**REPORT - PLANNING COMMISSION MEETING
March 10, 2005**

Project Name and Number: Greenbriar Homes Communities – Deer Road (PLN2005-00188)

Proposal: To review and provide comment on a conceptual grading design for the development of single-family homes on a 4+/- acre site off of Deer Road. In general, the proposal involves utilization of flat building pads instead of split pads in a Single Family Residential (R-1-6) Hillside Combining Area (H-I) and Open Space (OS) District zoning districts.

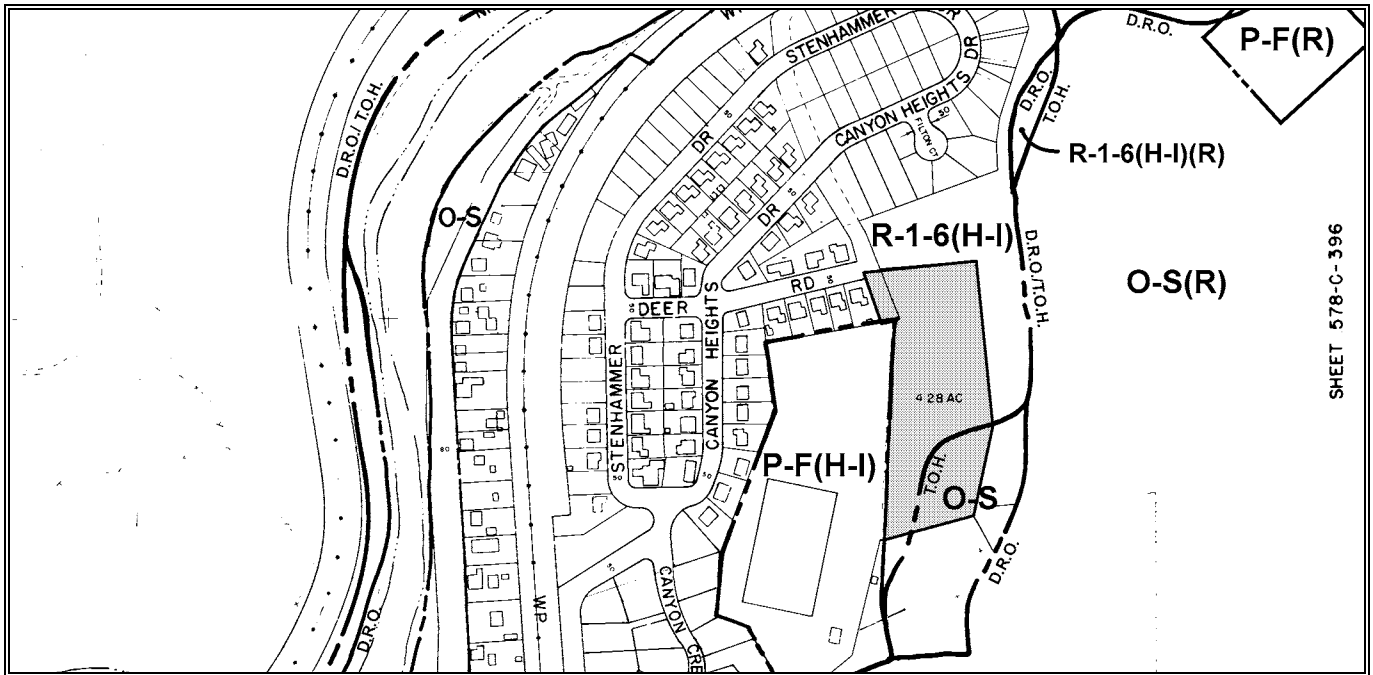
Toe of the Hill: The ACWD property is partially within the Hill Area as defined by City staff's proposed Toe of the Hill line. The Toe of the Hill, as defined by Measure T, is "*a line along the base of the hills, where the natural grade first becomes twenty percent (20%) or more...*". The applicant's engineer has shown a Toe-of-Hill line, which differs from City staff's recommendation, on both Site Plan Alternative A and Site Plan Alternative B. According to the applicant's engineer, the line was determined by measuring the slope between ten-foot elevation contour intervals.

Staff feels that the topographic survey data available allows the slope analysis to be done at more precise five-foot elevation contours. Staff's analysis of the topography resulted in a Toe of the Hill that is: lower on lot 1 (at approximately the 210-foot contour); higher on lots 3 through 7 (at approximately the 230-foot contour); and lower on lots 8 through 10 (at approximately the 210-foot contour). Although the purpose of this Preliminary Review Procedure is *not* to determine the location of the Toe of the Hill line, the final location may impact the type of grading that allowed above the Toe of the Hill line. The refinements to the Toe of the Hill line will occur at a later date in subsequent Planning applications for this site.
